# DRP024V240W1AA 產品升級通告

PCN-21-001 發表日期: 2021/02/01

#### **Output Ratings / Characteristics**

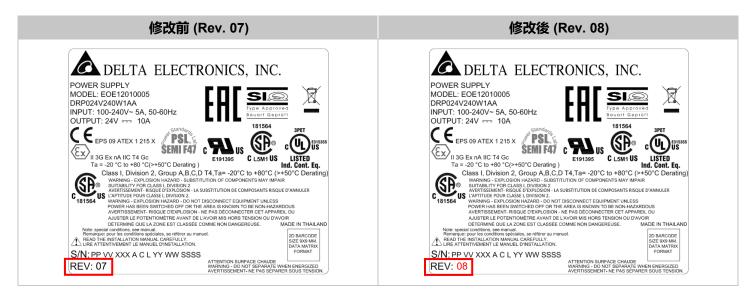
由於某些關鍵零組件 EOL, DRP024V240W1AA 型號會將輸出電壓調整範圍從 "22-28Vdc" 修改為 "24-28Vdc"。可在 DeltaPSU 網站上取得更新的產品規格表和使用手冊。

Nominal Output Voltage	24Vdc
Output Voltage Tolerance	± 2% (initial set point tolerance from factory)
Output Voltage Adjustment Range	22-28Vdc
Output Current	10.0A (continuously operating at 24) 15.0A (Power Boost for 3 seconds at 24V, refer to the details in the Functions section)

Nominal Output Voltage	24Vdc	
Output Voltage Tolerance	± 2% (initial set point tolerance from factory)	
Output Voltage Adjustment Range	24-28Vdc	
Output Current	10.0A (continuously operating at 24) 15.0A (Power Boost for 3 seconds at 24V, refer to the details in the Functions section)
